Access Compliance Report Public Rights-of-Way (Curb Ramps)

Main Street: HYDRANGEA_ST		Cross Street: SKLAR_ST		Location:	SW
ADA ID: RPRK211103130947	Ramp Type:Type 1 - Perpendicular	Initial Pass/Fail: Pass	Overall Compliance: No	Severity Score:	16

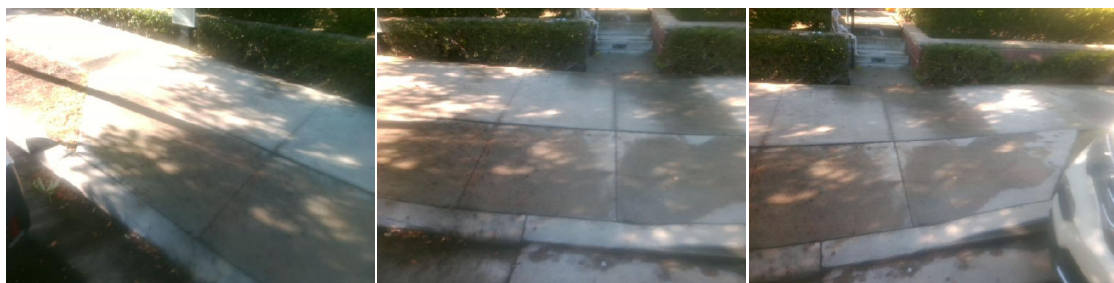
Compliance	Description	Data	Compliance	Description	Data
N/A	Ramp Length (in)	43	N/A	Flare Type LT	
Yes	Ramp Width (in)	48			Sloped
Yes	Ramp Run Slope (%)	7.6	N/A	Flare Slope LT (%)	11.5
Yes	Ramp Cross Slope (%)	3.1	N/A	Flare Traversable LT	No
N/A	Landing Present	Yes	N/A	Flare Type RT	
N/A	Landing Length (in)	58			Sloped
Yes	Landing Width (in)	48	N/A	Flare Slope RT (%)	6.1
No	Landing Run Slope (%)	2.8	N/A	Flare Traversable RT	No
No	Landing Cross Slope (%)	2.8	No	DWS Provided	No
N/A	Landing Movement Obstructed?	Yes	N/A	DWS Contrast	N/A
	Landing Movement Type	Bushes	N/A	DWS Length (in)	N/A
N/A	Landing Shared	Yes	N/A	DWS Full Width	N/A
N/A	Clear Space	N/A	N/A	DWS Offset Left (in)	N/A
N/A	Clear Space To Crosswalk (in)	N/A	N/A	DWS Offset Right (in)	N/A
N/A	Marked Crosswalk 1	No	N/A	Marked Crosswalk 2	N/A
	Crossing 1 Direction	E		Crossing 2 Direction	N/A
	Marked Crosswalk 1 Width (in)	N/A		Marked Crosswalk 2 Width (in)	N/A

N/A	Ramp Inside Crosswalk 1	N/A	Yes	Ramp Inside Crosswalk 2	N/A
	Crossing 1 Slope (%)	4.7		Crossing 2 Slope (%)	N/A
	Crossing 1 Cross Slope (%)	3.6		Crossing 2 Cross Slope (%)	N/A
Yes	Gutter Ponding	No	No	Curb Slope	17.3
Yes	Gutter Lip Height (in)	0		Road Run Slope (%)	N/A
No	Gutter Run Slope (%)	9.8		Road Cross Slope (%)	N/A
No	Gutter Cross Slope (%)	5.3			
Yes	Overall Surface Condition: Acceptable		Yes	Perp Joint Present	Yes
	Cross Gutter Present?	No		Spandrel Present?	No
	Replace Cross Gutter?	N/A		Replace Spandrel?	N/A

Remove & Replace Entire Ramp. Remove & Replace Gutter.
